**Progress on the development of new UN GTRs
and of amendments to established UN GTRs:****UN GTR No. 6 (Safety Glazing)****Authorization to develop an amendment
to UN Global Technical Regulation No. 6 (Safety Glazing)****Submitted by the representative from Republic of Korea***

Request for authorization to develop an amendment to global technical regulation No. 6 (Safety Glazing)

Figure 4
Determination of Zone 1

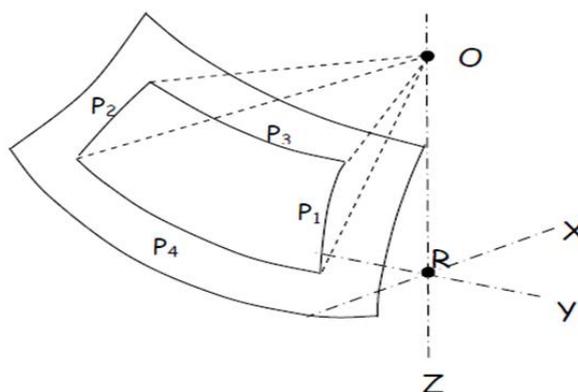
- (v) Para. 7.1.3.3.2. Zone I is the zone determined by the intersection of the windscreen with the four planes defined below:

In addition, opaque obscuration can be exempted in Zone I. It is the limited areas where it is intended that a sensing device, e.g. a rain-drop detector, rear view mirror or autonomous vehicle sensors, will be bonded to the inner side of the windscreen. The opaque obscuration where such devices may be applied is defined in paragraph 7.1.3.2.4.(Figure 2(a) or Figure 2(b)) of this annex.

P1 a vertical plane passing through O and forming an angle of 15° to the left of the median longitudinal plane of the vehicle;

P2 a vertical plane symmetrical to P1 about the median longitudinal plane of the vehicle.

If this is not possible (in the absence of a symmetrical median longitudinal plane, for instance) P2 shall be the plane symmetrical to P1 about the longitudinal plane of the vehicle passing through point O.

P3 a plane passing through a transverse horizontal line containing O and forming an angle of 10° above the horizontal plane;

P4 a plane passing through a transverse horizontal line containing O and forming an angle of 8° below the horizontal plane;
